NH PUC Docket DE 16-441:

Petition of PSNH d/b/a Eversource Energy to Construct and Maintain
Electric Lines, Neutral Wire and Fiber Optic Cable Over/Across the
Public Waters of the Oyster River and Little Bay in the Town of Durham,
Pickering Brook and Little Bay in the Town of Newington

SUMMARY
Revisions between Originally Submitted Petition
And Revised Engineering Design

F107 LINE CROSSING
LITTLE BAY

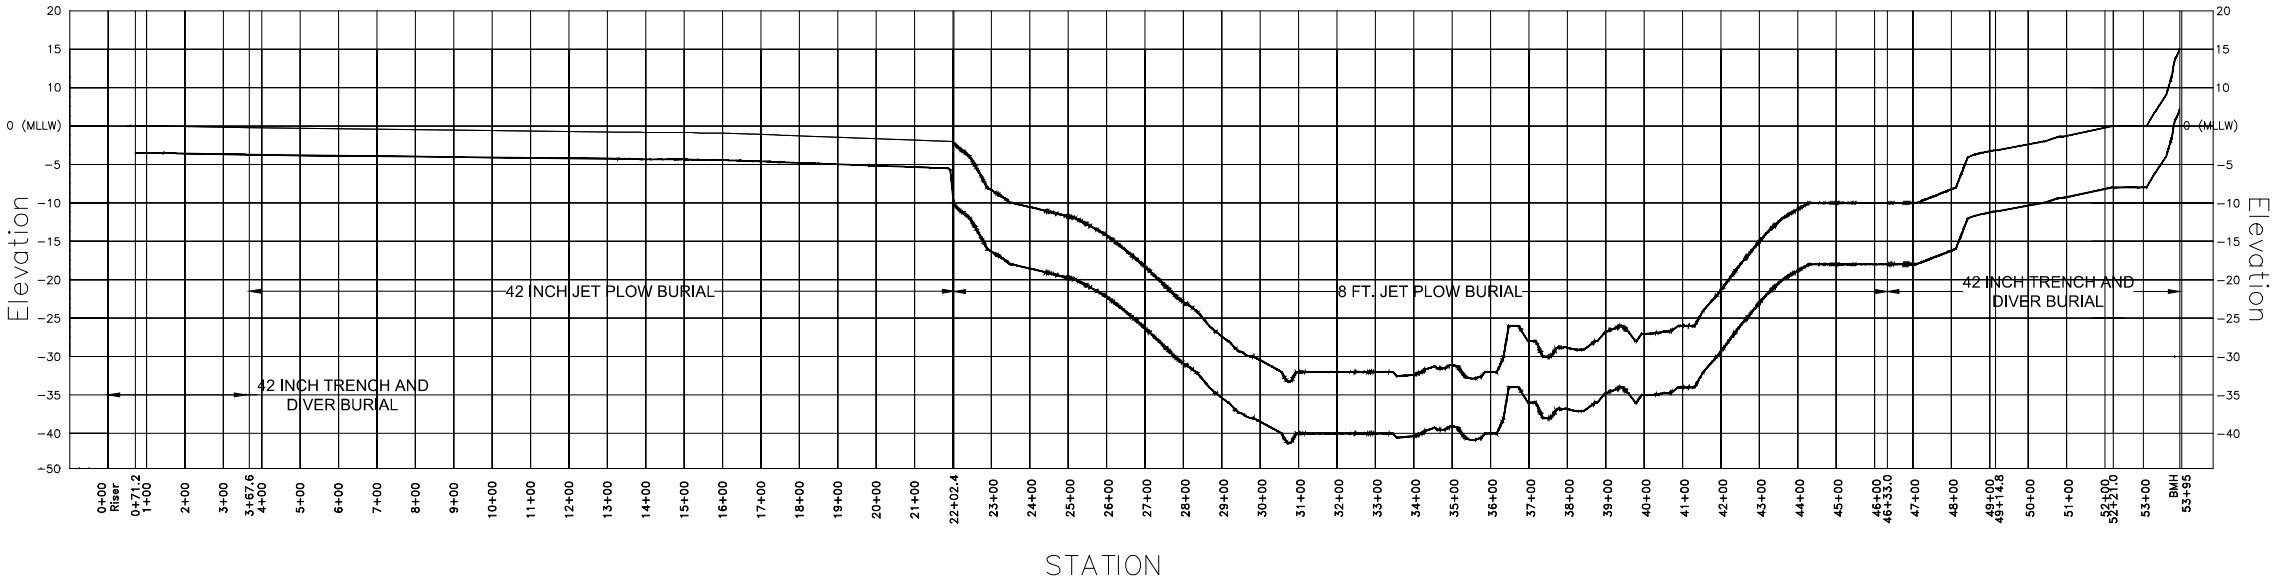
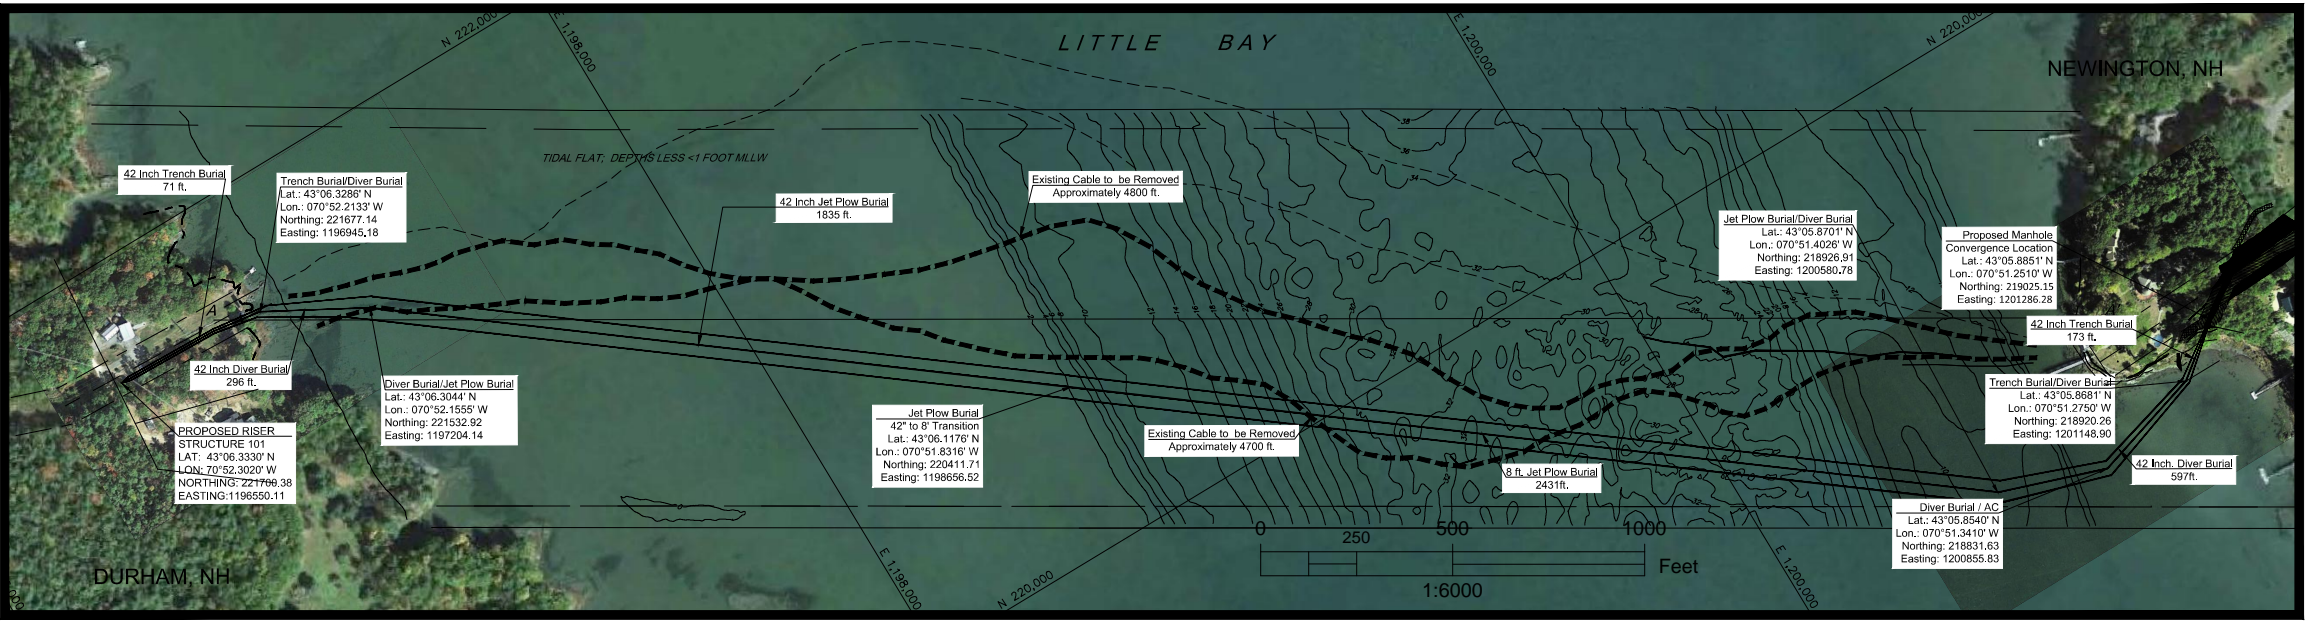
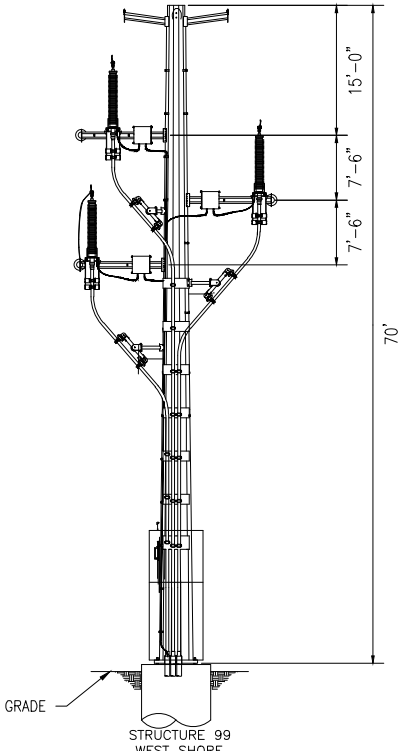
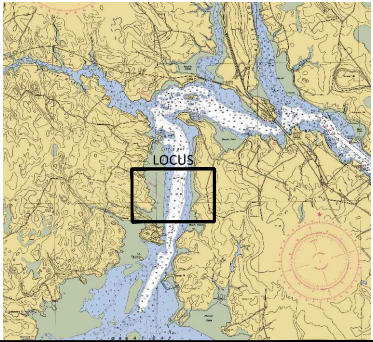
1. Paragraph #1- Revised Drawing number F10740905 (Exhibit 7) has been supplied.
2. Paragraph #1- **Change** "PSNH" **to** "Eversource Energy"
3. Paragraph #3- **Change** "80 feet" **to** "70 feet"
4. Paragraph #3- **Change** "6 to 12 feet" **to** "7.5 to 15 feet"
5. Paragraph #3- **Clarification**- Davit arms on steel structure are approximately 10 feet long.

NO.	REVISION	DATE	DRWN	CHKD	APPR
9	Revised: Border, Riser Structure & Manhole Dimensions	1/17	-	-	-
8	Rev. 08/Issue 01	1/16	-	-	-
